UNITED STATES PATENT AND TRADEMARK OFFICE

APPLICATION NO.	FILING DATE	FIRST NAMED INVENTOR	ATTORNEY DOCKET NO.	CONFIRMATION NO.
10/688,663	10/16/2003	Norman Shendon	770C6-099006	1195
7590	06/03/2004		EXAMINER	
			NGUYEN, GEORGE BINH MINH	
			ART UNIT	PAPER NUMBER
			3723	
DATE MAILED: 06/03/2004

Office Action Summary	Application No.	Applicant(s)
	10/688,663	SHENDON ET AL.
	Examiner George Nguyen	Art Unit 3723

DETAILED ACTION

Fig. 3A

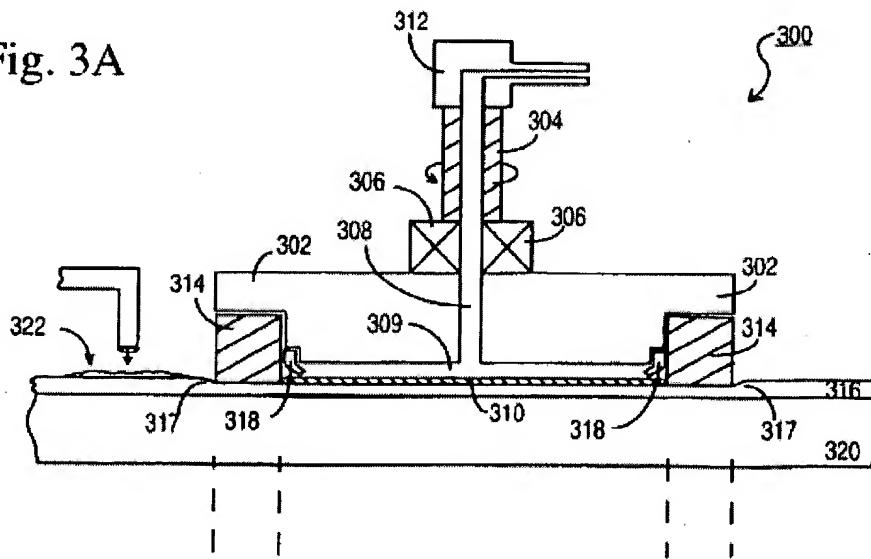
With reference to Fig. 3A, col. 4, line 25 to col. 5, line 25, Breivogel discloses the claimed invention.

Please note that the limitation of "housing" is broadly claimed that it could read on a housing supported the polishing pad. Thus, the backing member 302 is movable relative to such housing. Regarding to claims 5-6, the recess is the area created by the lip seal in combination with front surface of the backing area.

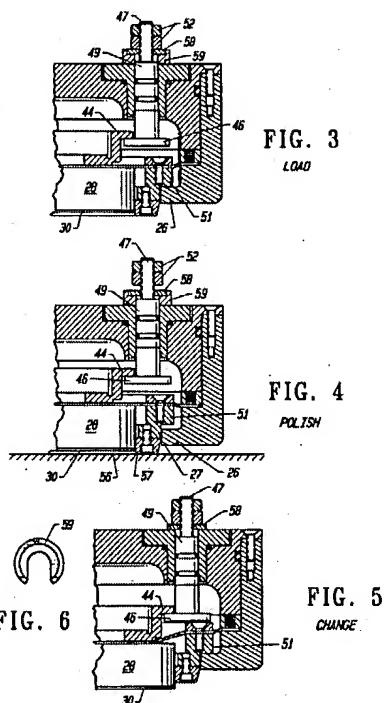
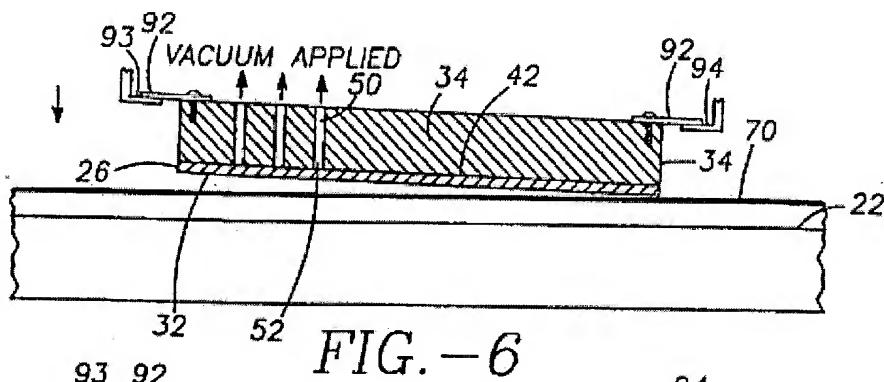
With reference to Figs. 3-5, col. 5, line 46 to col. 6, line 10, Shendon discloses a wafer polishing head that enables a wafer retainer to float during polishing and yet independently extends beyond the backing member 28 to control the movement of wafer during polishing or changing the wafer.

Please note that Shendon teaches a 1st chamber 23 between housing 12 and backing member 28. The 2nd chamber is the volume underneath membrane 29,

5. Thus, it would have been obvious to one having ordinary skill in the art at the time the invention was made to have modified the polishing apparatus of Breivogel with a retainer ring and 1st chamber and 2nd chamber as taught by Shendon to control the movement of the wafer.
